MEETING MINUTES

Cleveland Elementary School Modernization

Franklin Elementary School Modernization

Jackson Elementary School Modernization

FRANKLIN BUSH SCHOOL
 SCALE: 1/8" = 1'-0"

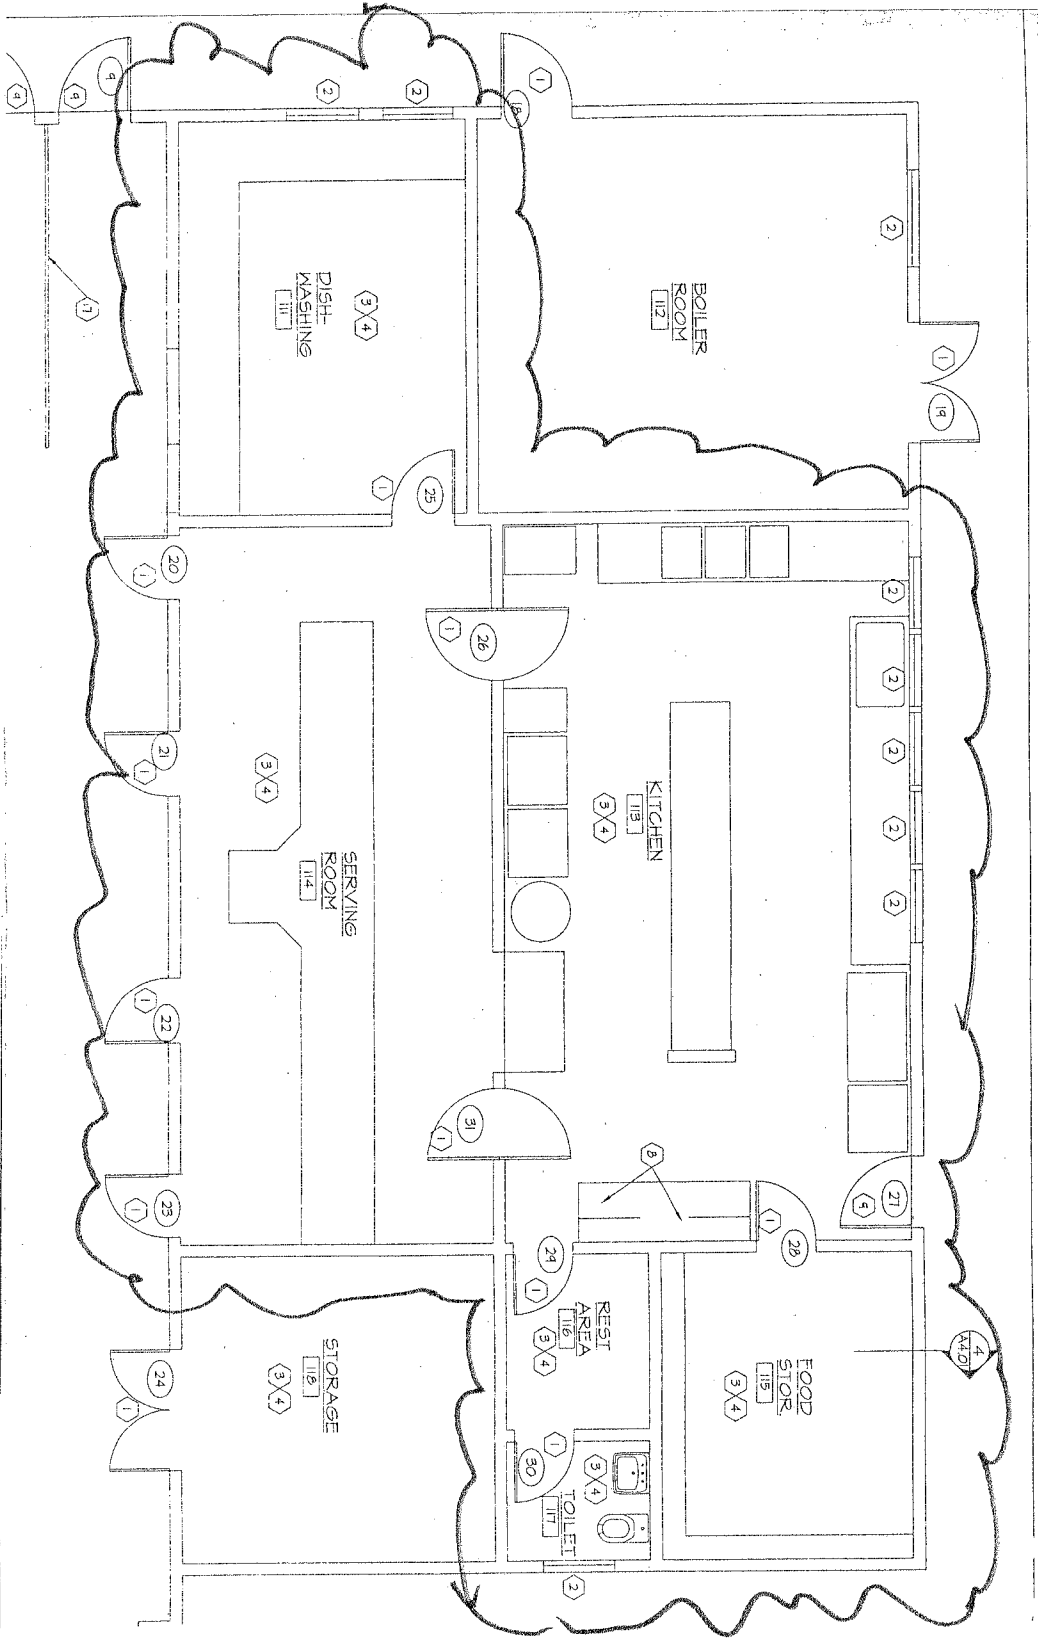
1. The District stated that the Storage Room adjacent to the Kitchen (identified as the Dishwashing Room per the attached drawing) is not needed. It may be used as a staff dining room or the layout could be redesigned to allow students access to the Cafeteria through that space.
2. There is currently no ventilation in the Kitchen. Replace existing window with new fixed windows.
3. A hand sink will be provided for the Kitchen.
4. The smaller refrigerator may be salvageable. It may be refurbished and reused.
